Environment Agency

Review of an Environmental Permit for an Installation subject to Chapter II of the Industrial Emissions Directive under the Environmental Permitting (England & Wales) Regulations 2016

Decision document recording our decision-making process following review of a permit

The Permit number is: EPR/EP3133RZ
The Operator is: Uniper UK Limited
The Installation is: Ratcliffe On Soar Power Station
This Variation Notice number is: EPR/EP3133RZ/V006

Figure 1. Schematic of UK freshwater plant and the flows of discharge streams to water

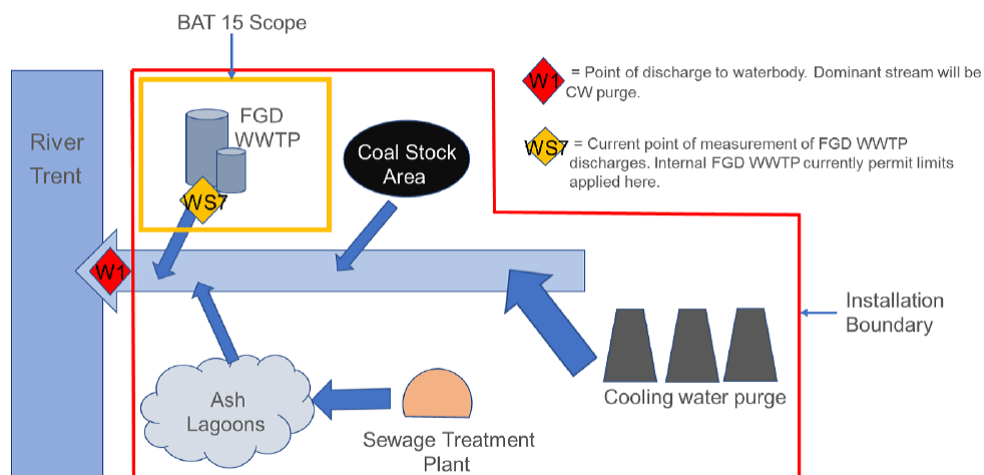
For this installation, the Operator has confirmed that releases to surface water from the site arise from many sources including ash lagoons, coal stockyard run-off, surface water drains, FGD waste water treatment plant, sewage treatment plant and cooling water purge. Where required, these individual releases are treated separately before being combined into a single waste water stream prior to release at the site boundary as shown in Figure 1 below.

The BAT-AELs stated in the LCP BREF BAT Conclusion 15 are applicable at the point of release to water body i.e. at W1 in Figure 1 the installation boundary, with FGD WWTP emissions only falling in scope.

Currently the permit sets a minimum flow of 700l/s at W1 before discharge at WS7 is permitted. On this basis with exception of Total Suspended Solids of the Operator proposes compliance with BAT-AELs be demonstrated at the point of discharge by application of relative flow balances measured at W1 (final site discharge) and WS7 (FGD WWTP) and is accepted.
